# 2014 - 2015 Corvette: GM TechLink: Break-In Oil Change for Corvette Included in Chevrolet Complete Care Program

**Subject:** Break-In Oil Change for Corvette Included in Chevrolet Complete Care Program

**Model and Year:** 2014 - 2015 Chevrolet Corvette Stingray with Z51 and Z06 Models

**Date:** January 22, 2015

**Fig. 2**

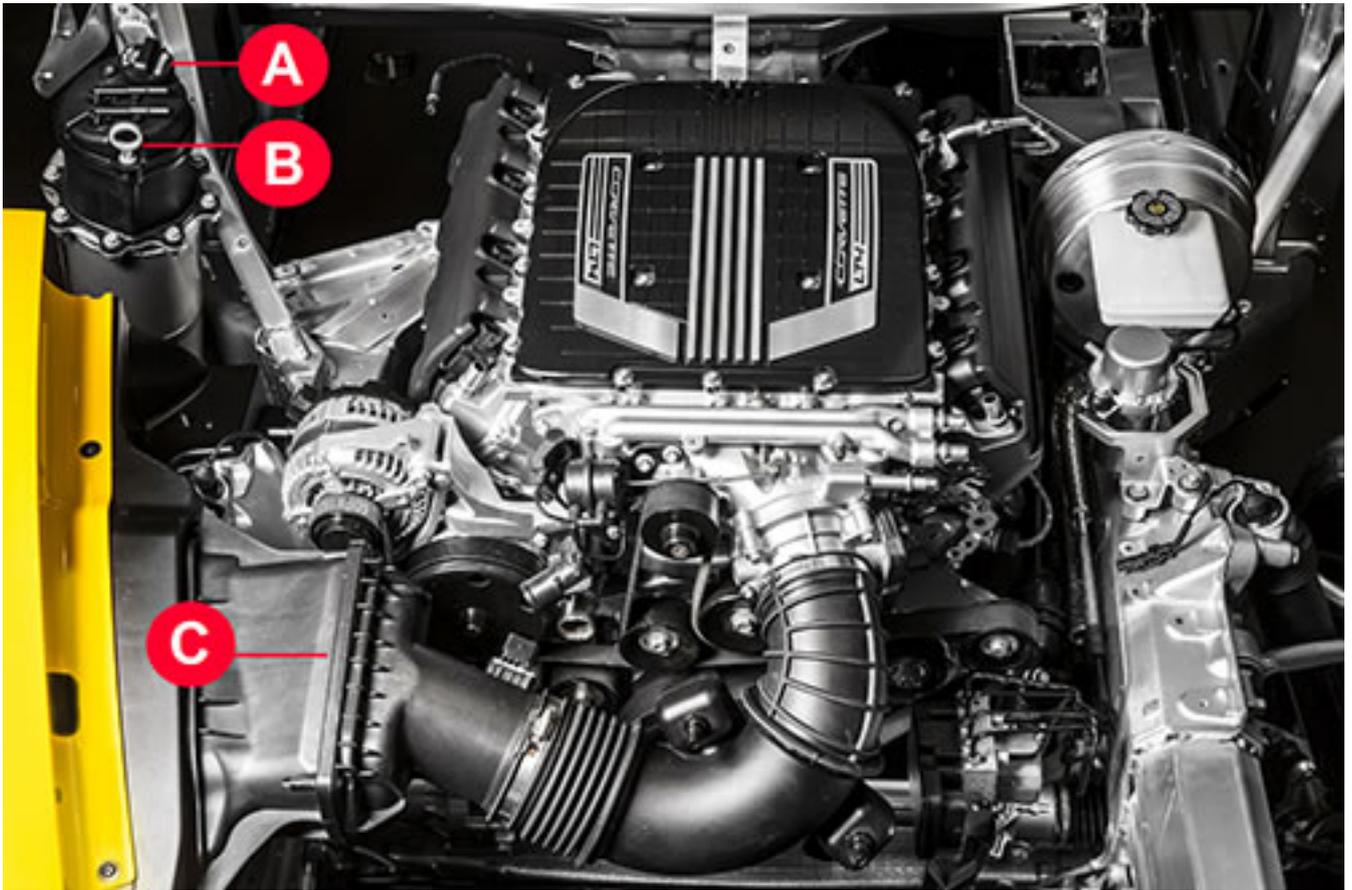
A new mileage interval has been established for the first engine oil change on 2014-2015 Corvette Stingray models with the Z51 Performance Package and Z06 models. These vehicles are equipped with an engine featuring a dry sump oil system. The first oil change should take place at 500 miles (800 km) on these vehicles.

If the vehicle is driven continuously at a high engine speed with the first factory oil fill, silicone sealants in the engine's gaskets may degrade the anti-foaming properties of the oil. This may lead to oil leaking out from the air cleaner assembly due to the oil foaming condition. The oil foam does not affect the engine's durability, but changing the oil at 500 miles will help prevent oil foaming in the future because the silicone sealants are removed with the original oil.

Once the break-in oil change is performed and the Oil Life Monitor is reset, owners should follow the Oil Life Monitoring system for all future oil change needs.
